MINUTES OF A REGULAR MEETING OF THE PLANNING AND ZONING COMMISSION, OF THE CITY OF PEARLAND, TEXAS, HELD MONDAY, MARCH 4, 1996, IN THE COUNCIL CHAMBERS AT CITY HALL, 3519 LIBERTY DRIVE, PEARLAND, TEXAS.

C. CONSIDERATION AND POSSIBLE ACTION - Preliminary Plat of Crystal Lake Subdivision.

D. CONSIDERATION AND POSSIBLE ACTION - Final Plat of Southwyck, Section Nine, Phase One.

TYP. CROSS SECTION
CRYSTAL LAKE SUBD.

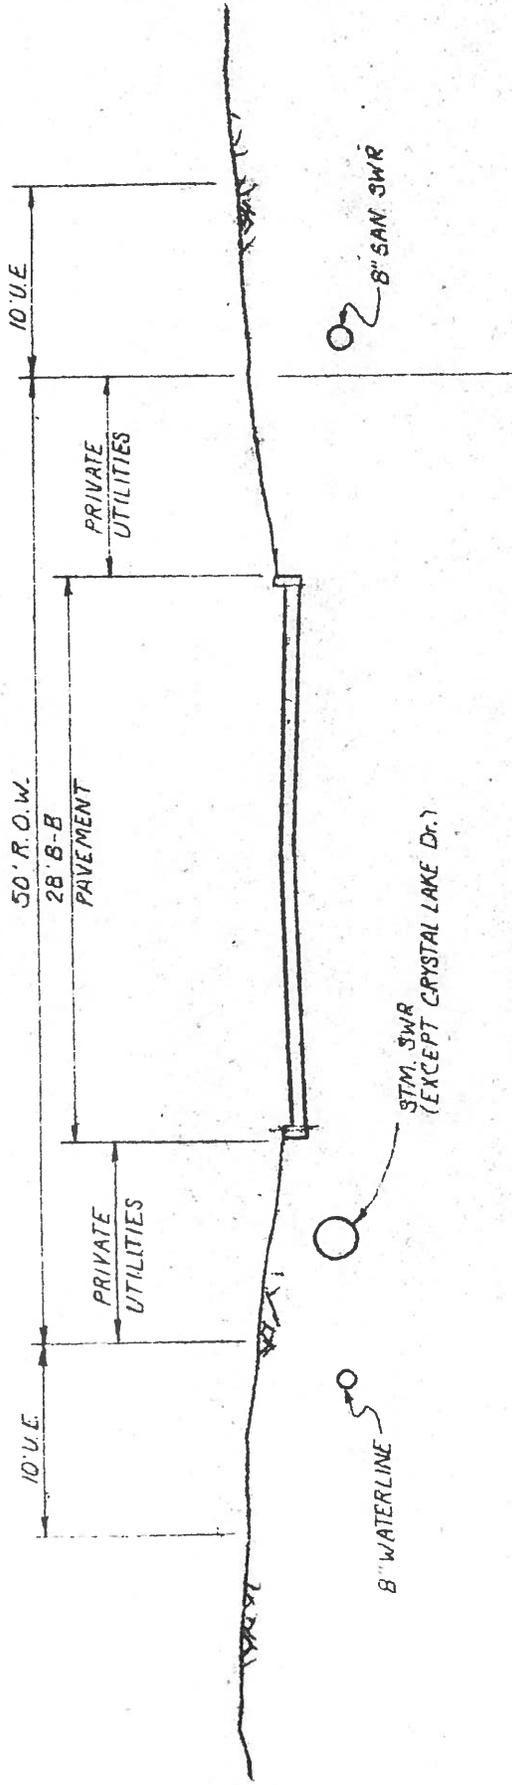
John Hargrove addressed several issues regarding this plat approval. Two of those issues were that utility companies are requesting all utilities be placed in the streets as opposed to the back lot lines on lots around the lake; and the 15' drainage easement which is referenced to the water line of the lake. His concerns are stability of elevation (horizontally and vertically), slope protection, and where the 15' drainage easement would end up in years to come. He indicated that he would like to see dry utilities put in the rear lot line and wet utilities placed in the front. He also would like to see the 15' maintenance easement described geometrically.

In reference to the City of Pearland review comments for Crystal Lake Subdivision, there is a note stating that all private utilities should be located in back of the lots, including electrical power. H. L. & P. has indicated that no electrical service will be located on the back lots that adjoin the lake. Based on this requirement, the electrical service is located at the front of the lots. To maintain uniformity within the project, all private utilities for the lots would be located in the street right-of-way.

In a meeting with Richard Berdine and Ronnie McWhirter on February 13, 1996, we explained this requirement of the private utility companies. To minimize future utility conflicts, we agreed to locate the water and sanitary sewer outside the street right-of-way in the adjoining 10 foot utility easement as shown on the attached sketch. This would leave the area within the right-of way and outside the pavement for locating the private utilities.

NOTE: ON ALL STREETS EXCEPT CRYSTAL LAKE DRIVE
 THE STORM SEWER ONLY CROSSES UNDER THE
 STREET AND WILL NOT BE RUNNING PARALLEL TO PAVEMENT.
